Summary of Meeting on Proposed Changes to the Nevada
Nuclear Waste Storage Investigations Exploratory Shaft Facility

April 14-15, 1987

PROPOSED CHANGES TO THE
NEVADA NUCLEAR WASTE STORAGE INVESTIGATIONS PROJECT
EXPLORATORY SHAFT FACILITY

Figure 3. Comparative Illustration of the Final EA Versus the Proposed Exploratory Shaft Locations

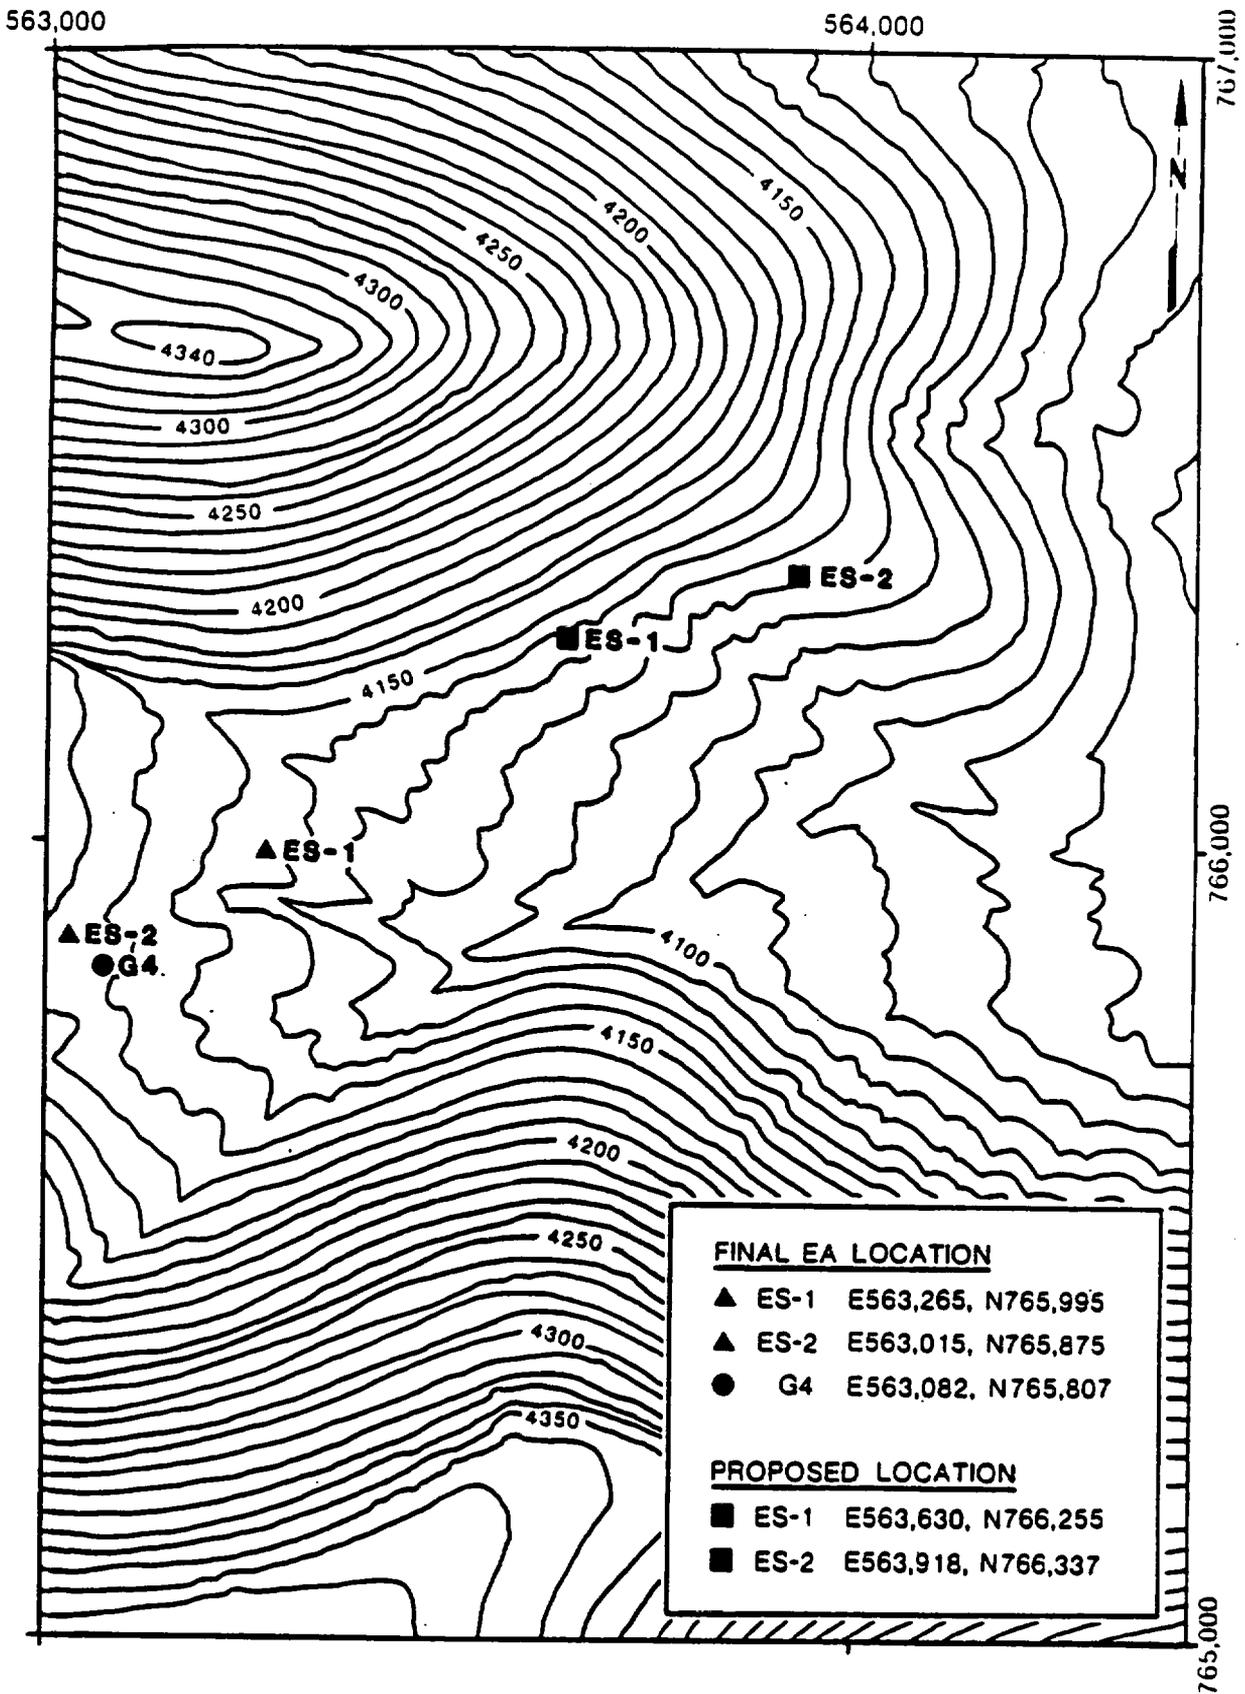
Relocation of the ESF exploratory shafts from the alluvial fill of Coyote Wash to a point where the shaft collar would be in rock reduces the potential for erosion of material immediately adjacent to the shaft. The participants concluded that the proposed shaft locations are acceptable pending demonstration that flooding and erosion do not adversely affect long-term repository performance. In presenting the performance analysis for the shafts DOE should incorporate the proposed changes in shaft location.

Because of the change in construction method for the proposed second shaft, DOE should provide reasonable assurance that the shafts are adequately separated so that construction in one shaft does not adversely affect ability to obtain required data in the second shaft and adjacent test areas.

Figure 4. Comparative Illustration of the Final EA Versus the Proposed Main Test Level Location.

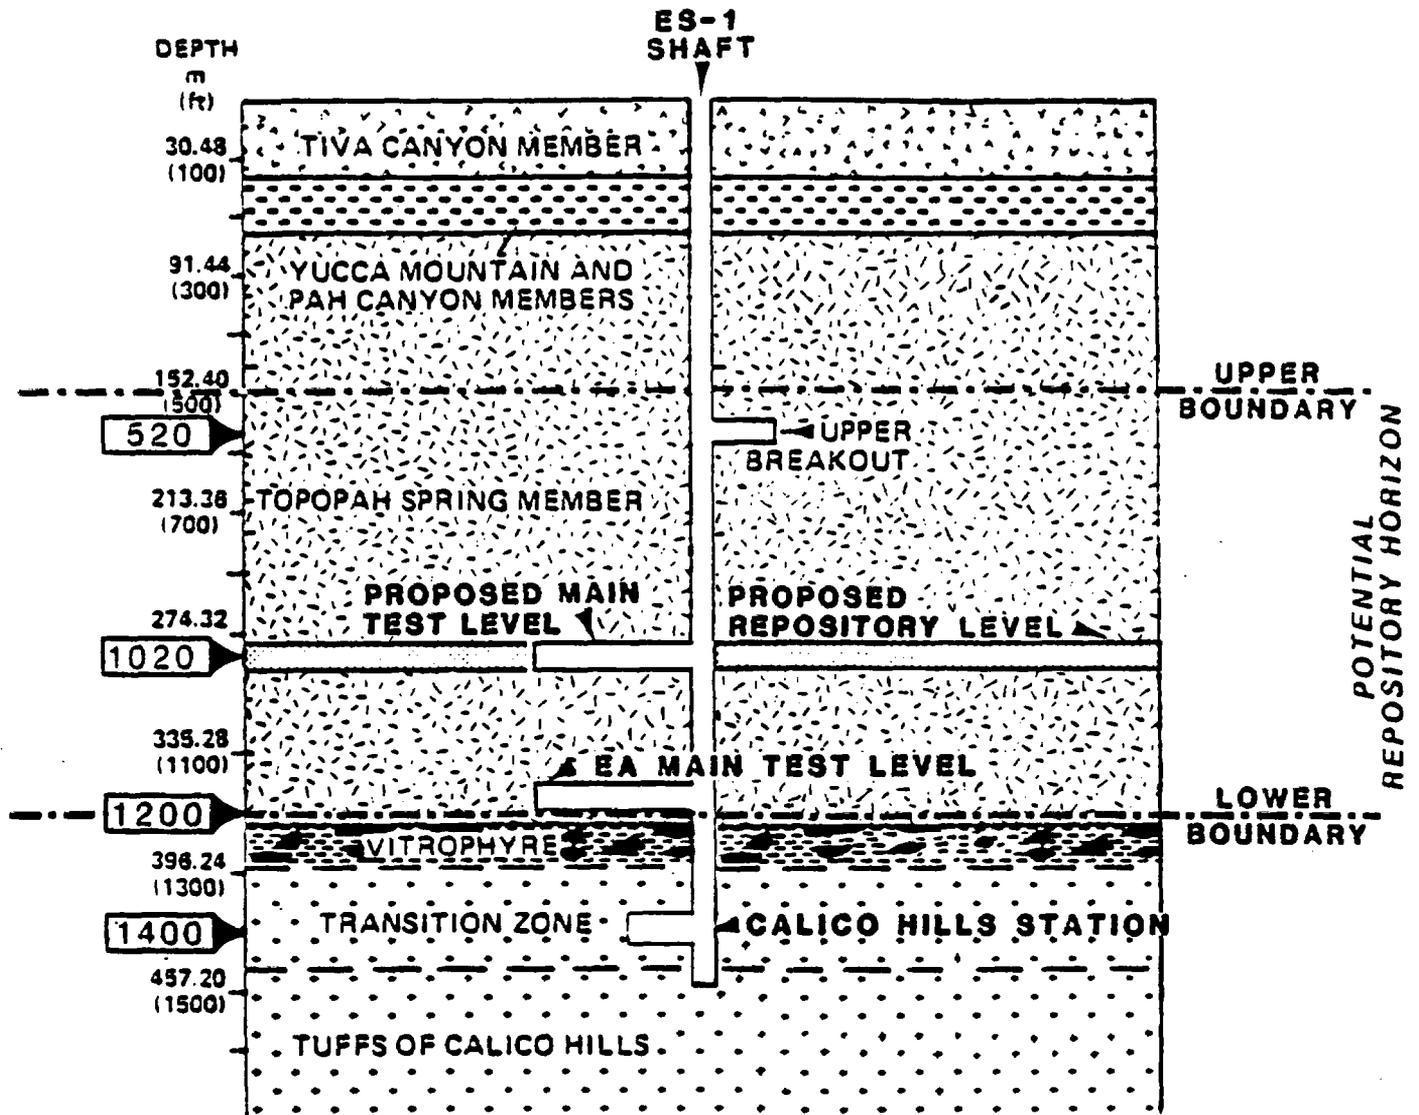
The participants endorsed the proposed relocation of the main test level to the intersection level between the proposed repository horizon and the exploratory shaft(s) because it provides confidence that the main test facility will be within the strata in which at least part of the repository will be located. This provides greater confidence in the representativeness of the results and conclusions from observations and tests with respect to the actual repository horizon. It is particularly valuable to have the extensive exploratory drifting within the actual repository horizon. This relocation also reduces concerns about the potential isolation consequences of having extensive test and exploratory excavations below the repository.

Figure 5. Relationship of ESF long drifts and the conceptual repository design.

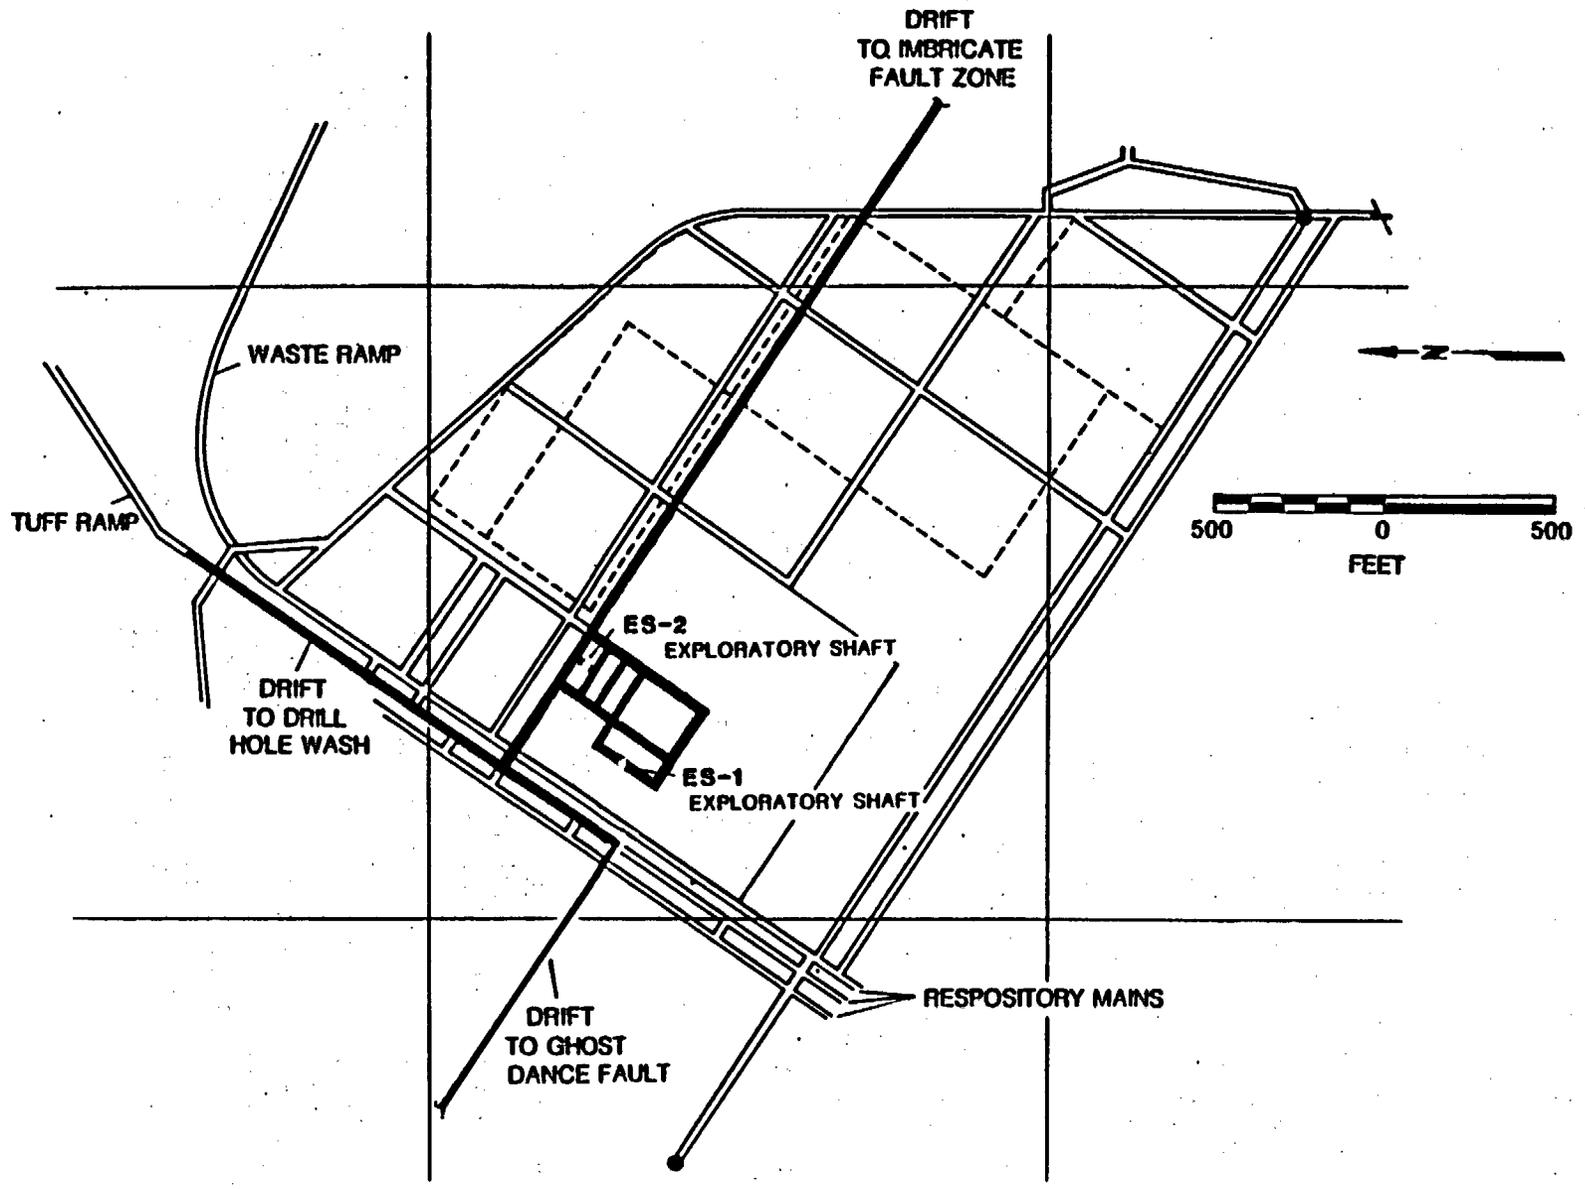
The NRC strongly feels that the proposed changes with regard to fault characterization using exploratory drifts represent an improvement over the original concept of using long exploratory boreholes. Thus, the DOE's proposal of constructing exploratory drifts for the purposes of investigating the three fault areas (Ghost Dance fault, Drill Hole Wash, and the imbricate normal fault system) is reasonable. However, the NRC is of the position that adequate construction controls have to be adopted to meet 10 CFR 60 pre-closure and postclosure performance requirements. Further, the DOE needs to recognize that penetrating these targeted geological/hydrological structures

may require remedial measures to maintain the postclosure isolation capability of the repository. Finally, the DOE should provide assurance that the planned drift lengths and directions are adequate for characterizing each of the targeted fault zones.

There was considerable discussion related to the size of the three exploratory drifts from the main test area out to: Ghost Dance Fault, Drill Hole Wash, and the imbricate normal faults. DOE stated that the drift sizes could range from a minimum size (e.g., 9 feet by 10 feet) up to repository, full-scale size (e.g., 14 feet by 21 feet or 19 feet by 25 feet), and were under internal DOE review. The State of Nevada indicated support for the full-size exploratory drifts from a geoenvironmental standpoint. DOE indicated in response to NRC, that the selected exploratory drift size(s) would be justified on a regulatory and technical basis (i.e., on the basis of site characterization needs consistent with 10 CFR 60.3 and the NHPA [Sections 112(a) and (c)]).

Figure 6. Comparative Illustration of the Final EA Versus the Proposed Main Test Level Arrangement.

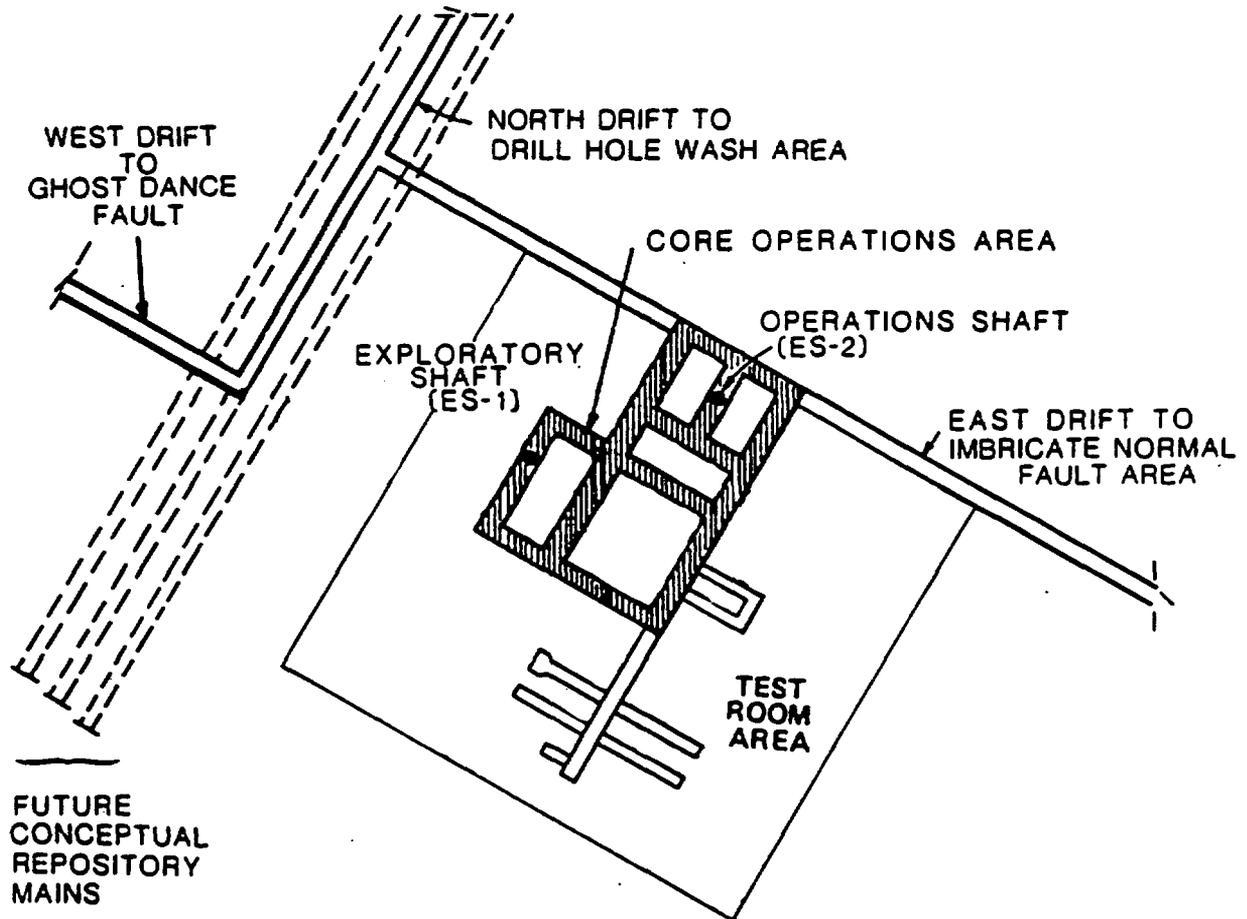
The NRC staff agrees with the increase of the main test area by 2,500 linear feet of drifts, provided the DOE demonstrates that it has taken adequate measures to avoid interference of tests from drifting operations and with each other. The increase of approximately 2,500 ft. of drifts should provide additional flexibility in better distributing the locations of site characterization tests. This flexibility can facilitate in providing adequate separation of the planned tests from the nearby exploratory drifting operations. Also, the tests can be sufficiently separated from each other to avoid interference.
